**HMC ARCHITECTS
3546 Concourses Street
Ontario, California 91764**

Arvin High School ESSER III Phase 1 Roofing

Kern High School District

File No: 15-H3 A#03-122508

A4.21

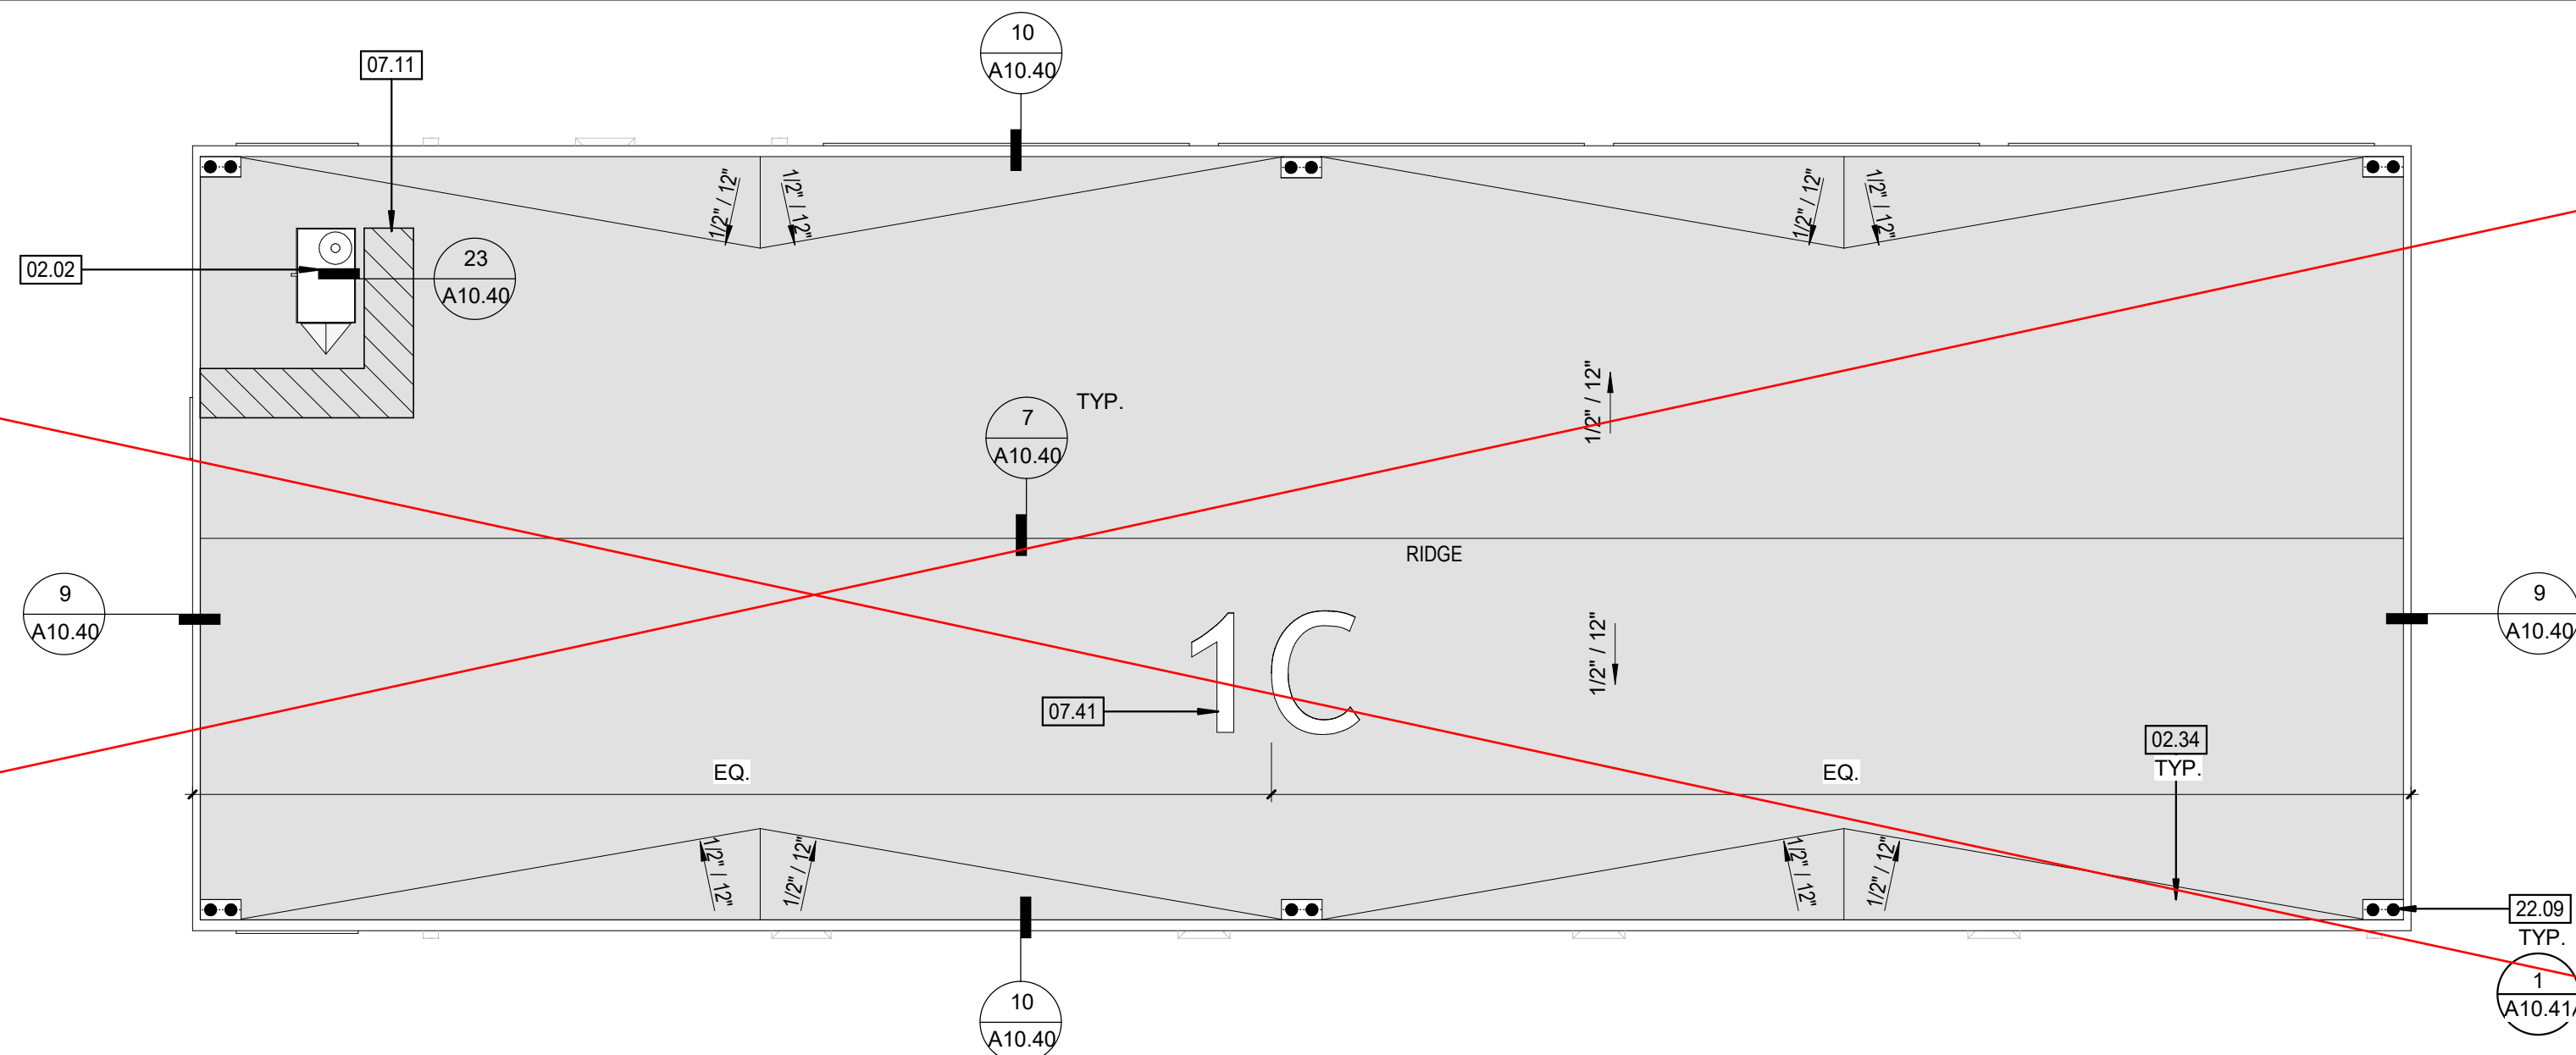
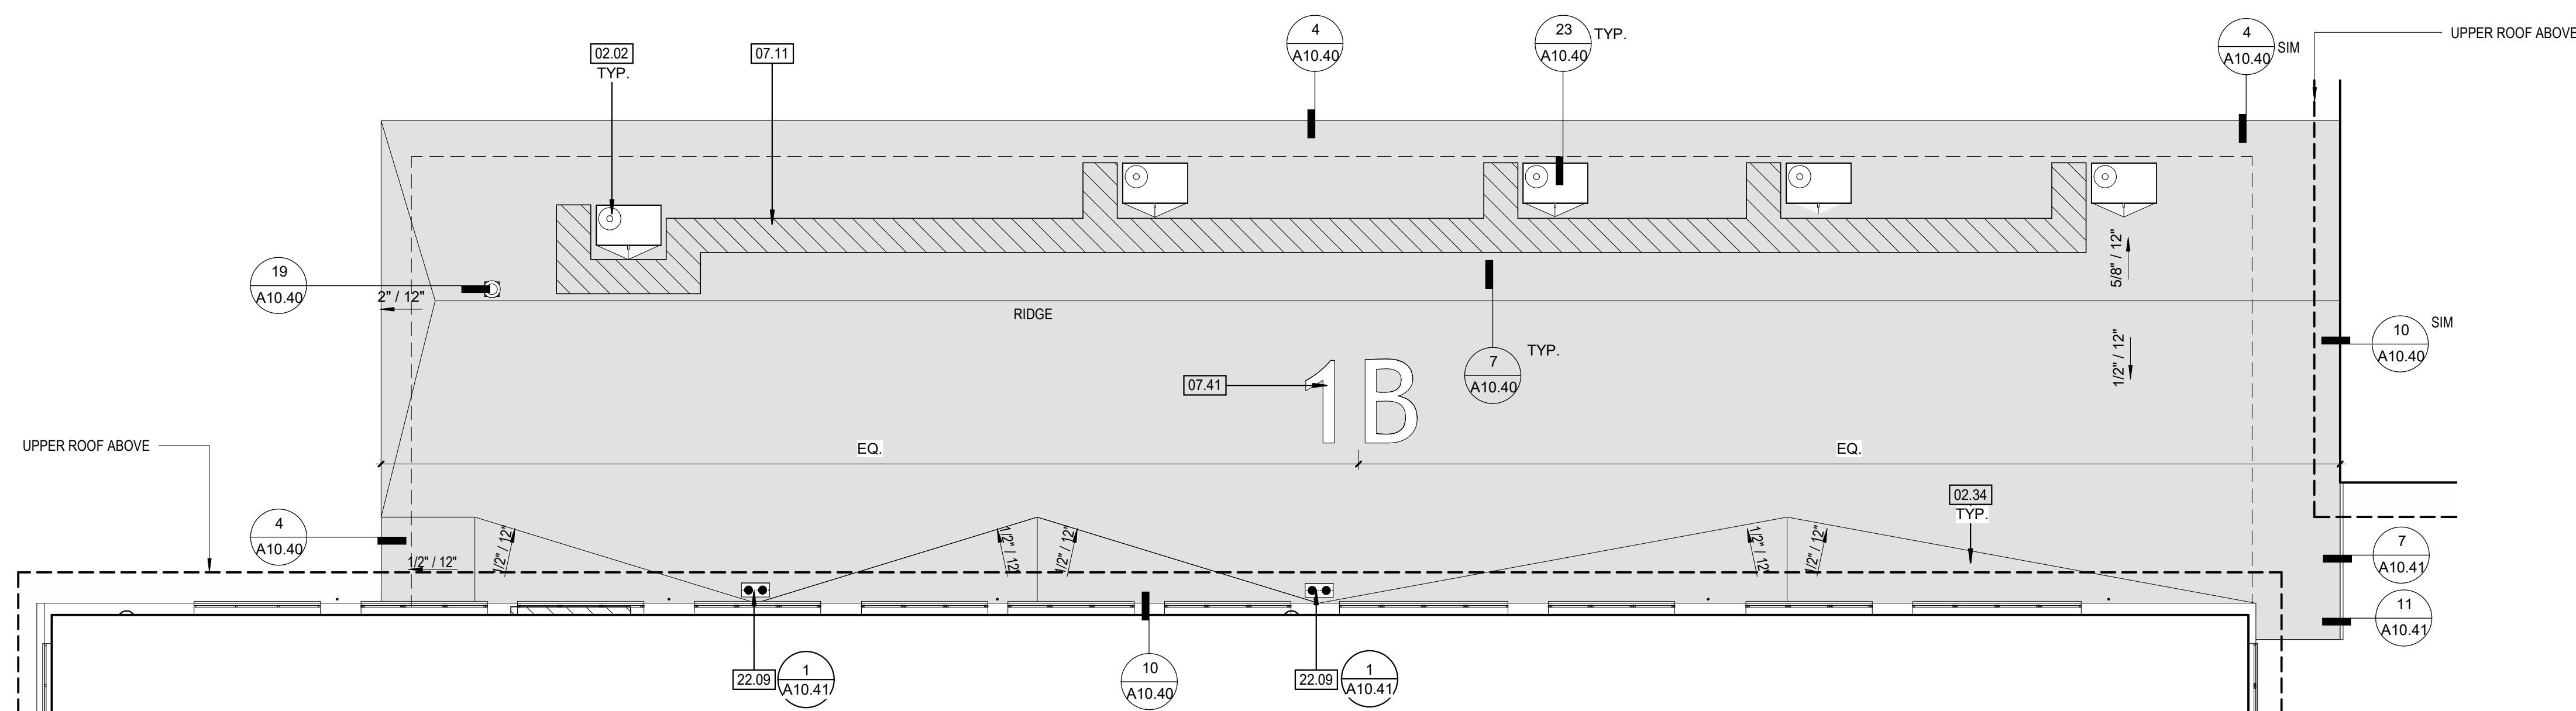
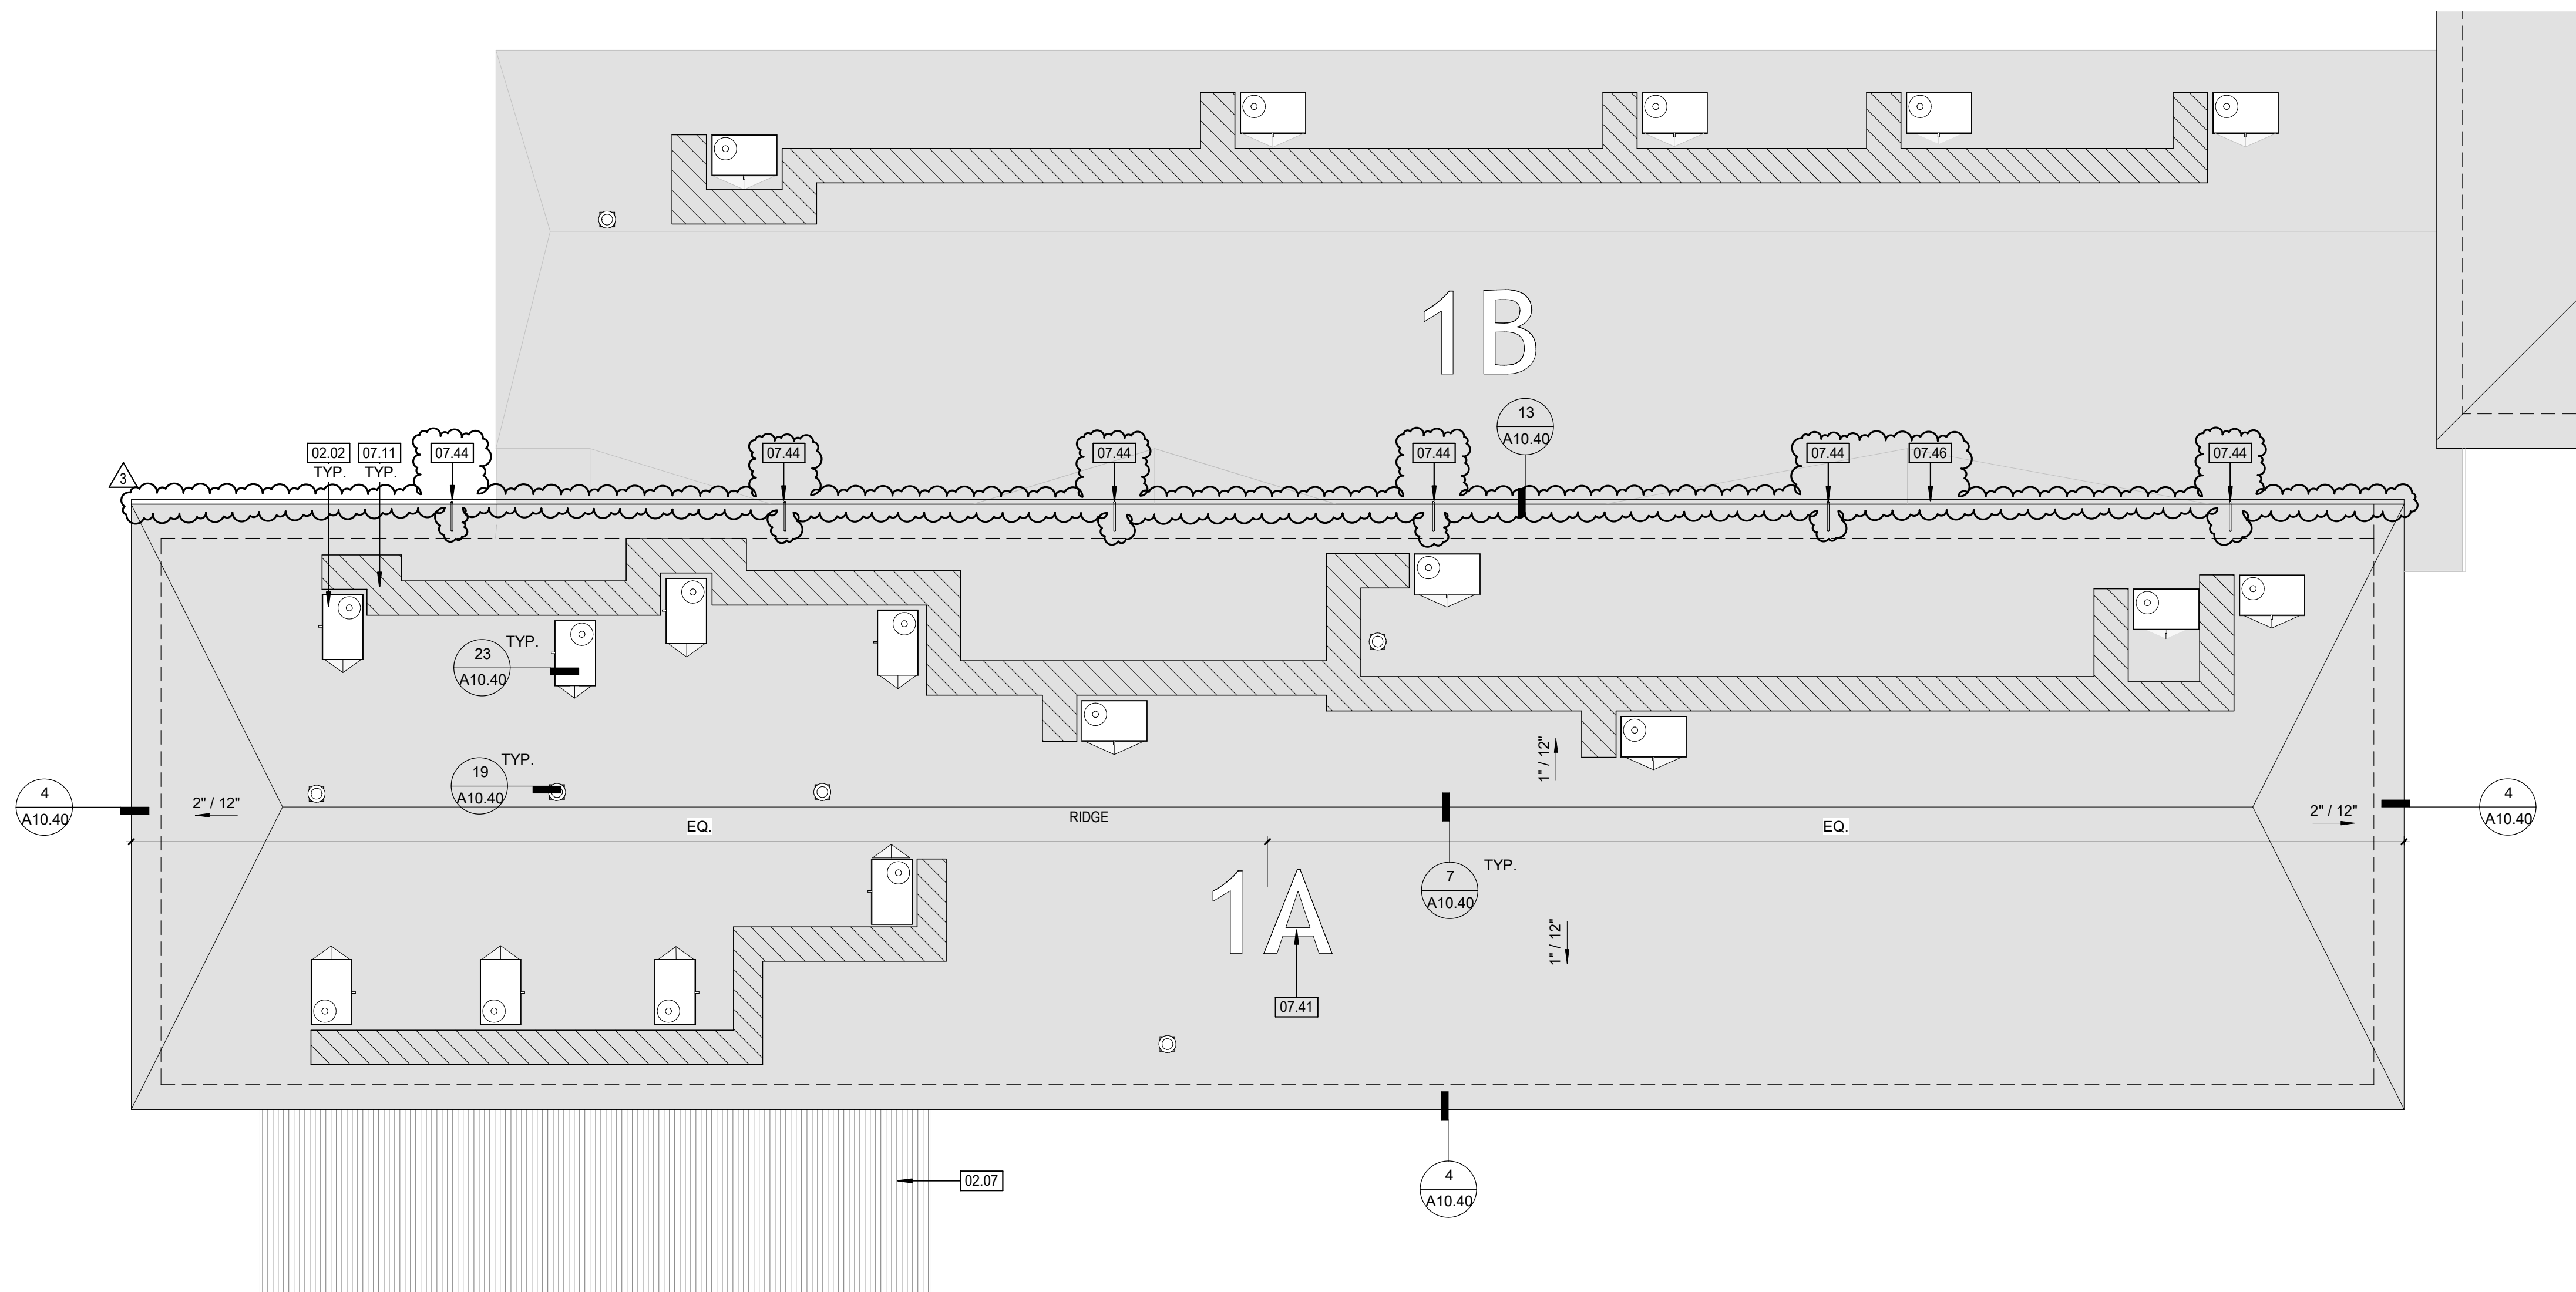
- 1.) ADD keynote 07.44 and 07.46 as shown and clouded per Delta 3.

SHEET NAME:
BLDG 5B & 7B - ROOF PLAN - DEMO & REMODEL

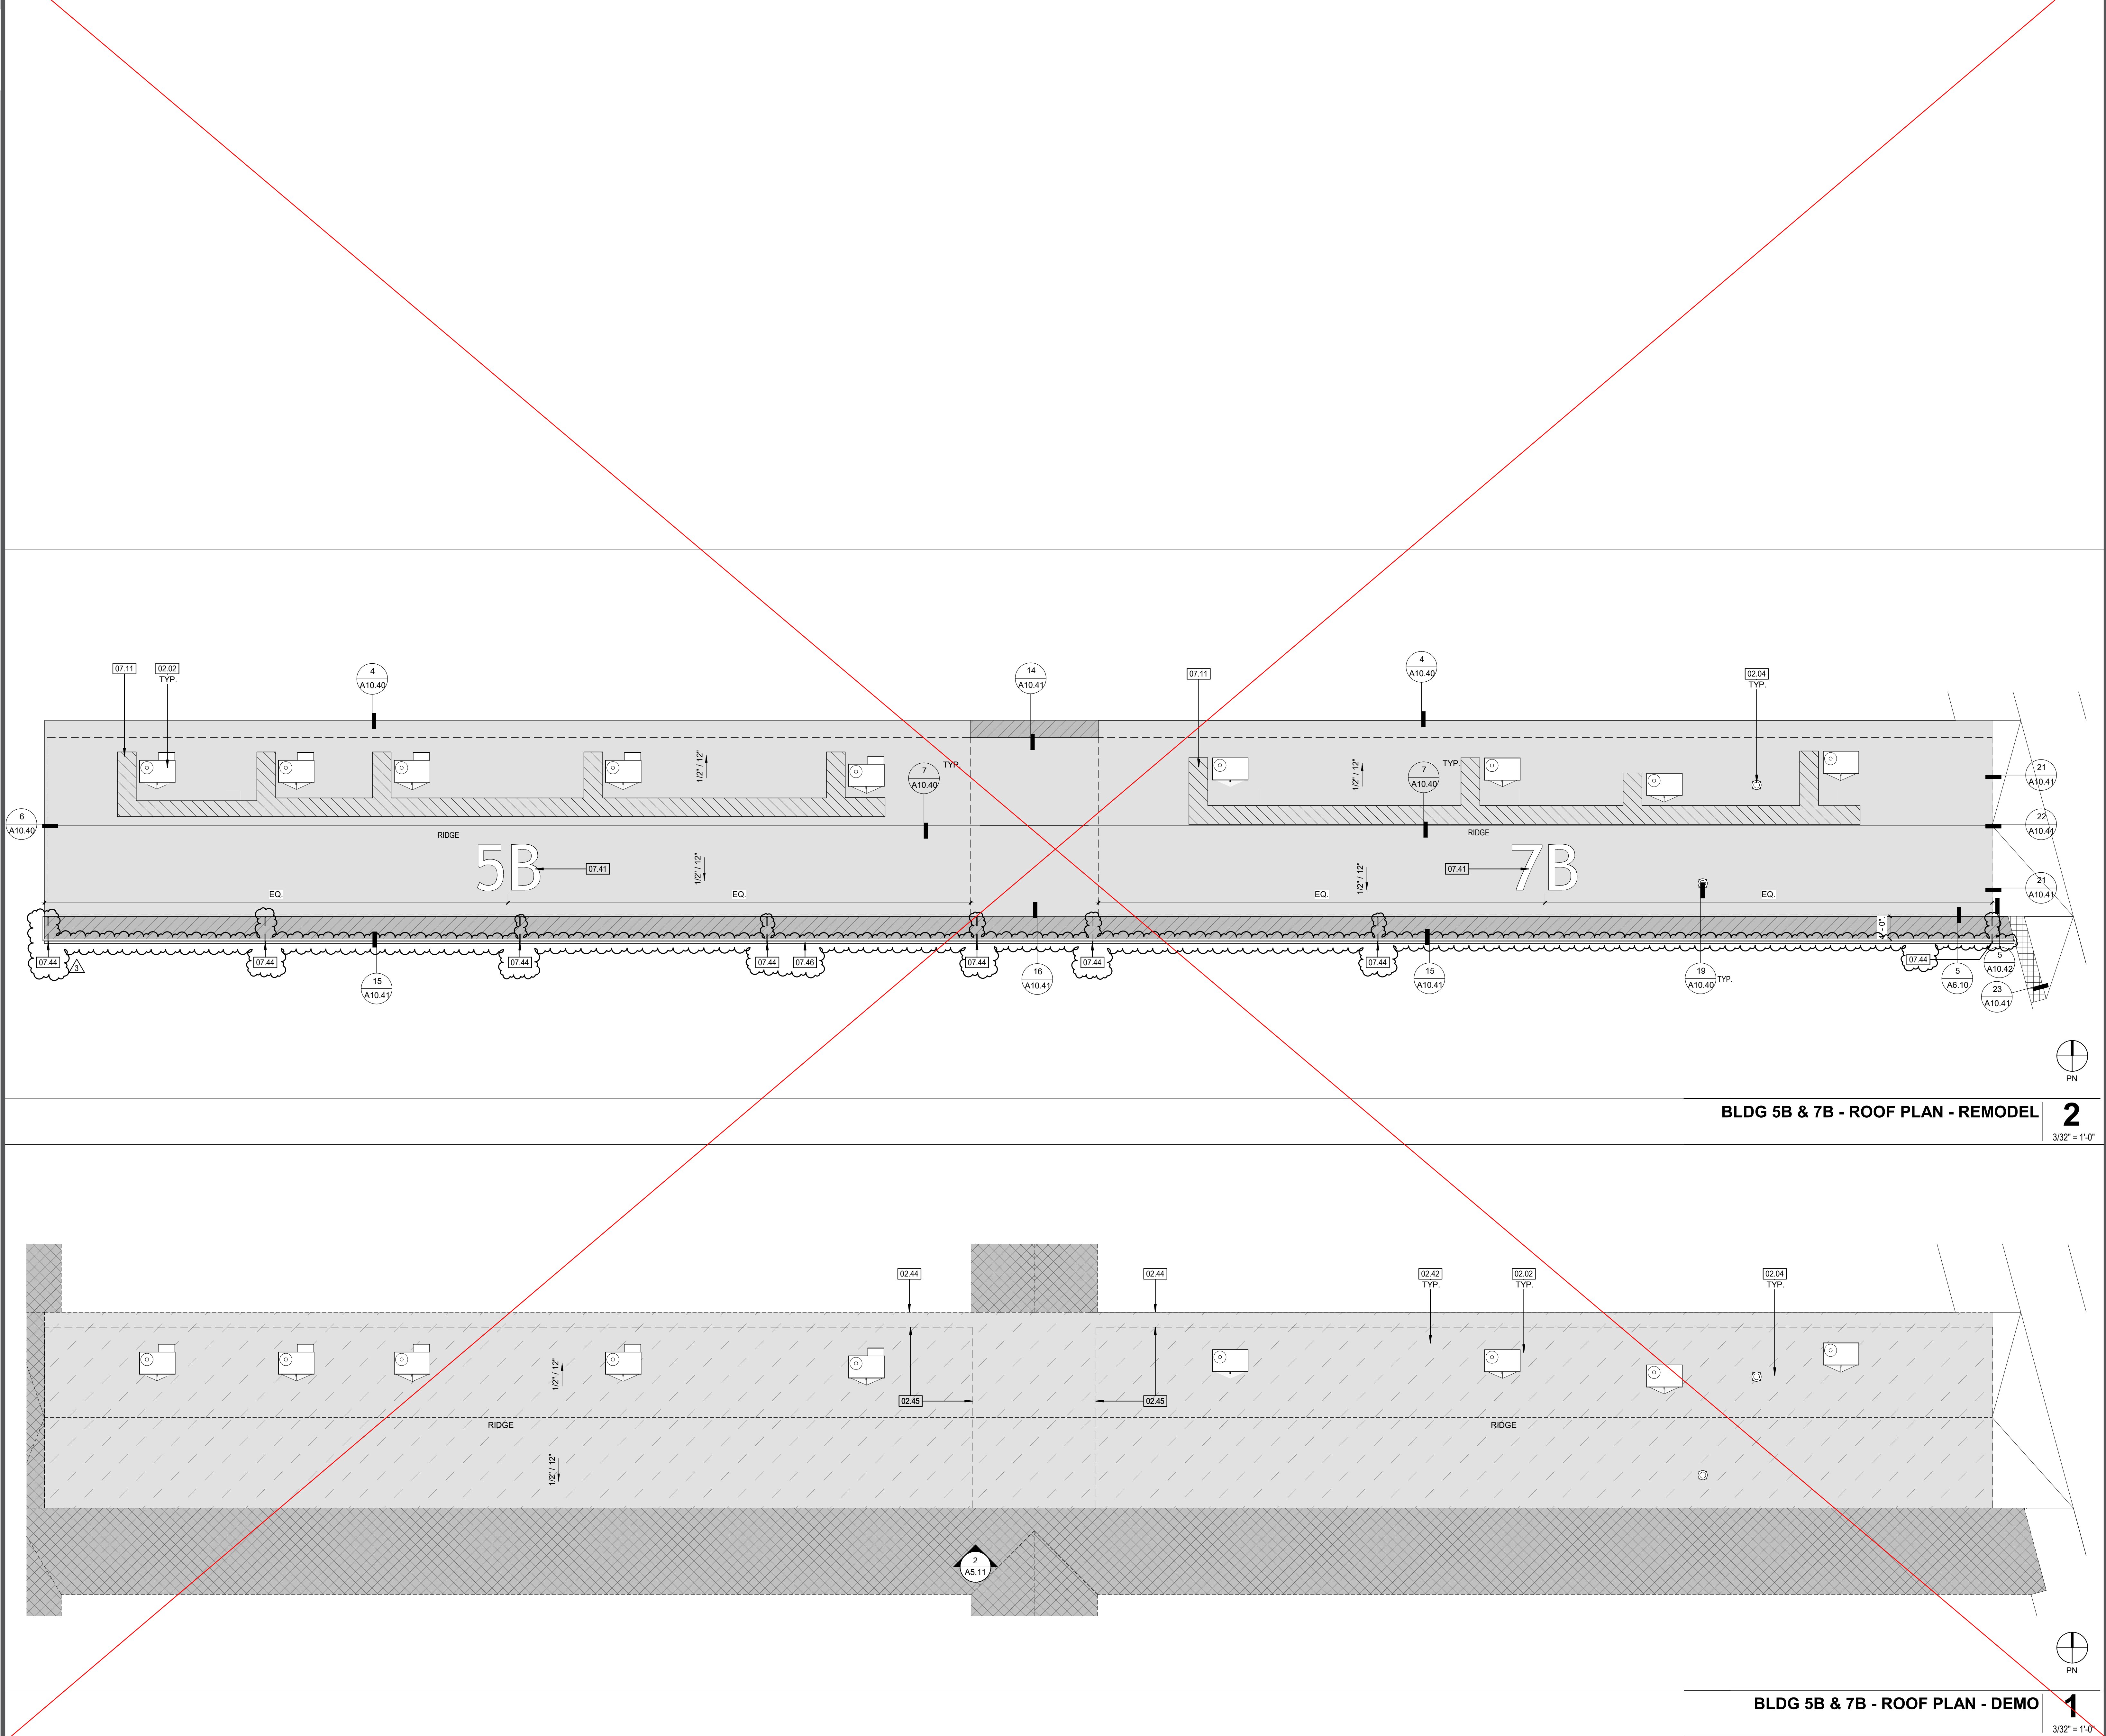
- 1.) ADD keynote 07.44 and 07.46 as shown and clouded per Delta 3.
